HISTORIC AND DESIGN REVIEW COMMISSION

August 01, 2018

HDRC CASE NO: 2018-303
COMMON NAME: Print Building
ADDRESS: 420 BROADWAY
LEGAL DESCRIPTION: NCB 432 (SAN ANTONIO LIGHT), BLOCK 16 LOT 14
ZONING: FBZ T6-1, HS, RIO-2
CITY COUNCIL DIST.: 1
LANDMARK: San Antonio Light Building
APPLICANT: Peter French/Gray Street Partners
OWNER: Graystreet 420 Broadway LLC
TYPE OF WORK: Exterior modifications to the Print Building and the construction of a connector addition to the Light Building
APPLICATION RECEIVED: July 13, 2018
60-DAY REVIEW: September 11, 2018
REQUEST:

SOUTH ELEVATION

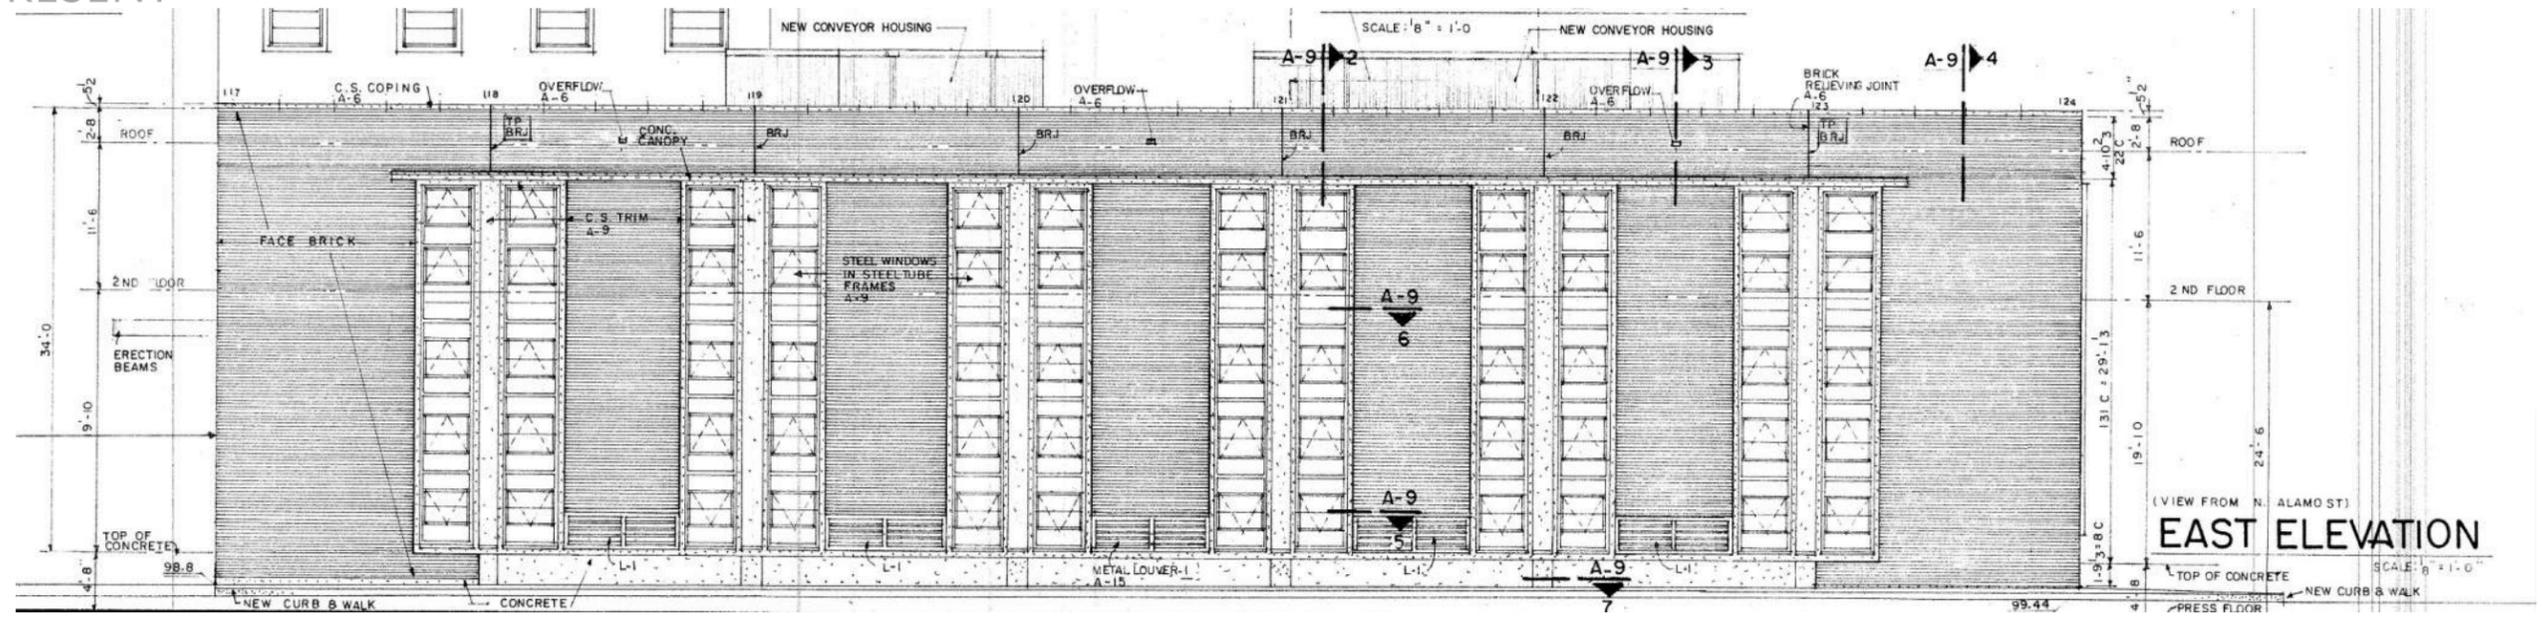
SL: WHY WAS WEST FACADE BRICK REMOVED? JS: REMOVED FOR CONSIDERATION OF NEW CONSTRUCTION.

AL: HOW DOES PROPOSED HEIGHT OF FINISH RELATE TO LIGHT BUILDING - SHOW IN ELEVATION.

JS: INTENT IS TO DESIGN NEW FACADES WITH ORIGINAL IN MIND (EAST AND SOUTH FACADES ONLY).

1968 EAST ELEVATION

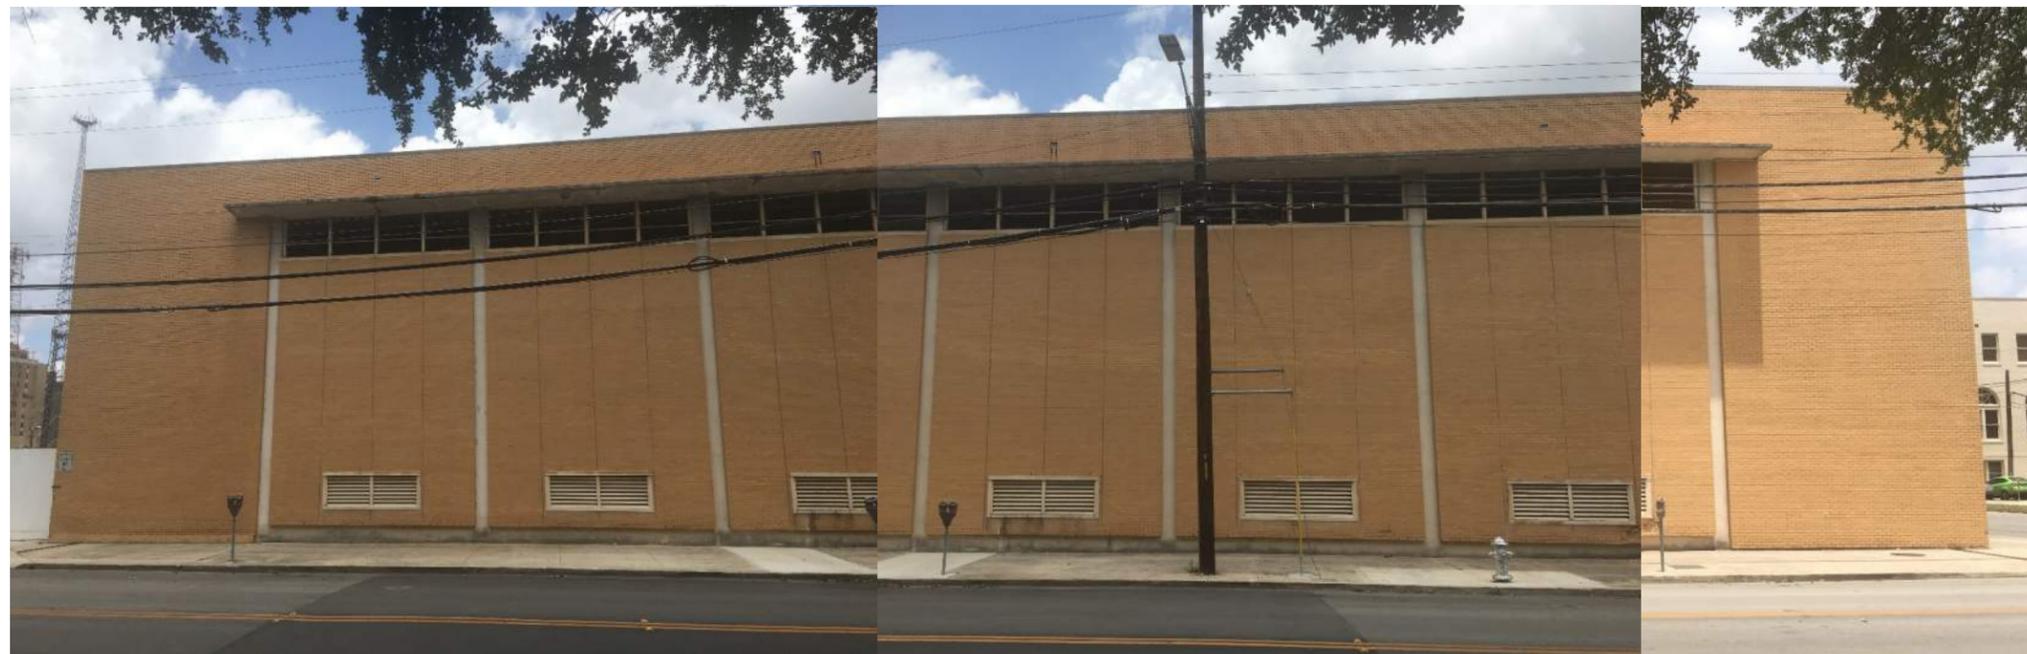
Staff finds the existing façade of the Print Building to hold architectural integrity as an example of the Mid-Century Modern style. Should the Historic and Design Review Commission find the proposed modifications to be inappropriate, staff recommends the original façade be reconstructed as it existed prior to demolition. Additional façade openings originally existed on the N Alamo façade and could be restored to allow for additional fenestration.

JF: BELIEVES STRUCTURE HAS HISTORIC VALUE. WOULD LIKE TO SEE NORTH AND EAST FACADES (SPIRITS) PRESERVED. BRICK COLOR SHOULD BE CHOSEN TO MATCH EXISTING. RESPECTING DIFFERENCE IN ELEVATIONS IS IMPORTANT. DOES NOT SEE ISSUE WITH ADDITIONS ON TOP - APPROPRIATE APPROACH.
